## Report on Batch N Opto Plug-Ins

Batch N comprises 38 TX modules, serial numbered ST196 to ST233 and 60 RX modules, serial numbered SR693 to SR752 (inclusive); received on 7th March 2005.

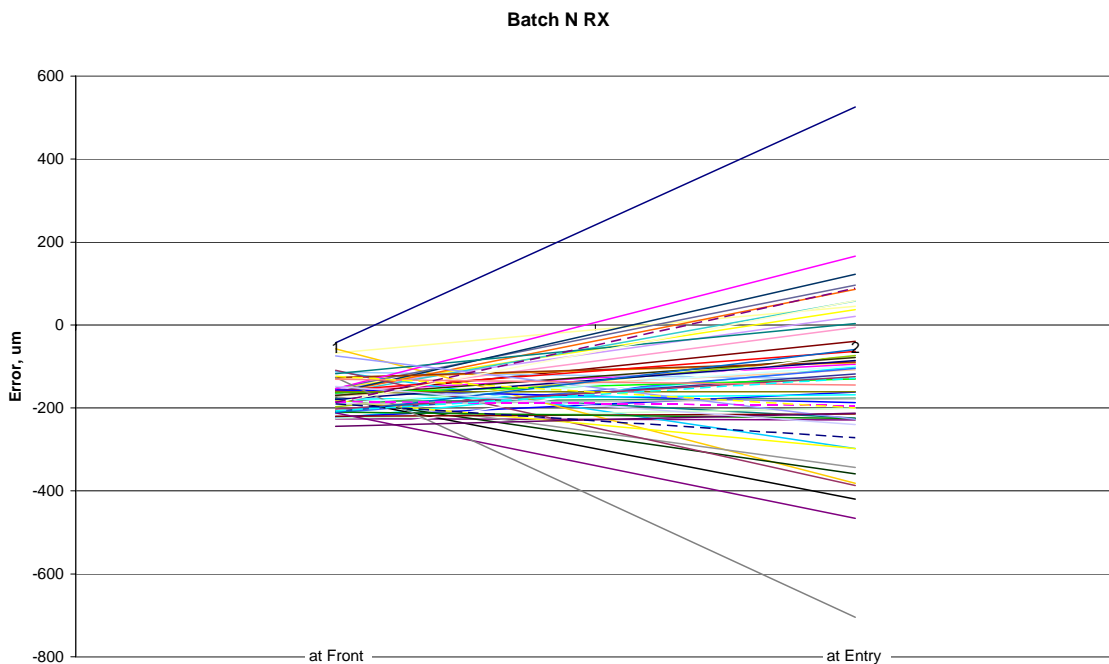
Firstly these modules were measured using the Profile Projector using the same method as for the previous batch. Of the TX modules 30 (79%) had a pin angle of  $0 \pm 1^\circ$  and the remaining 8 (21%) had a pin angle of 1 to  $2^\circ$ . However, looking at the mounting height of the array all were low, and only 2 low by less than 0.1mm, 20 (53%) being more than 0.2mm low. All were within 0.25mm. This can be illustrated by the “sticks” plot:

ST199

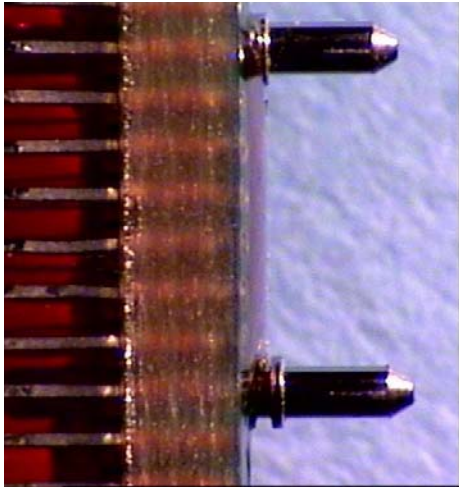
Two TX modules (ST199 & ST228) had pins which were not fully home, the shoulder on these pins therefore prevented the MT12 from meeting the guard wire and a large gap was left.

This was reflected in the electrical tests in that these modules were unable to deliver the required power into the fibre ribbon. One further module had BPM errors, one had no lasers coming on, and another had only the lasers for streams 0 – 5 coming on. Four more failed our data loop-back test on one or more streams. In all 9 TX modules failed the electrical tests, a pass rate of 76%.
